**CONDITIONAL APPROVAL
 PLAN APPROVAL EXPIRES: 07/16/2017**

Foremost Farms
 W3286 Cty Hwy F
 Town of Chilton
 Calumet County

Facility: 723504 FOREMOST FARMS
 W3286 CTY HWY F
 Plan Type: Addition-Alteration; 1 Interior Fixture(s)

Object Type: Commercial Water Treatment Device Regulated Object ID No.: 1544269

FOREMOST FARMS USA
 DRW. #: CHE13

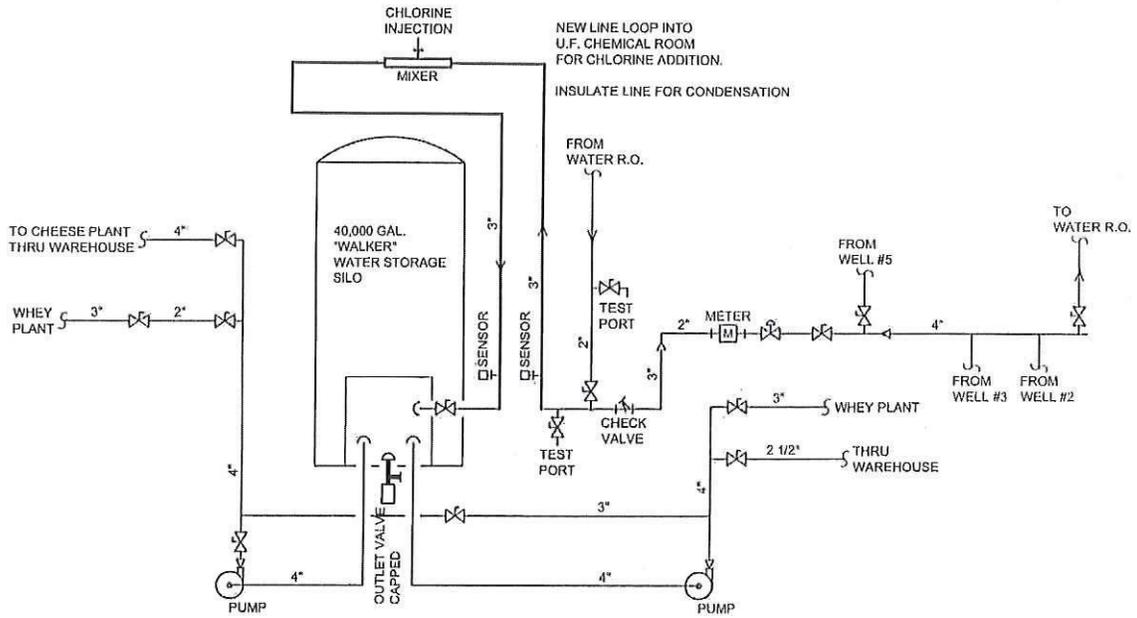
- This liquid chlorination system (i.e. sodium hypochlorite) was sized to provide 4 log (i.e. 99.99%) virus reduction in accordance with s. NR 810.53 at 10° C. The required minimum CT value is 6; the design of this system provides a CT value of 7.95.
- The chemical feed pump used shall be the Grundfos DDA 7.5-16 AR-PVC/E/C-F-31 | 003BG, MODEL A9772236610000205P11336.
- The sodium hypochlorite solution injected shall be NSF 60 listed Ecolab XY12 (8.4% NaClO):
<http://info.nsf.org/Certified/PwsChemicals/Listings.asp?CompanyName=&TradeName=xy-12&ChemicalName=&ProductFunction=&PlantState=&PlantCountry=&PlantRegion=>
- This installation shall undergo a final inspection prior to the system be put into serviced. The Plumbing Consultant having jurisdiction in this area is Phil Mnuk. Mr. Mnuk can be contacted via the following:
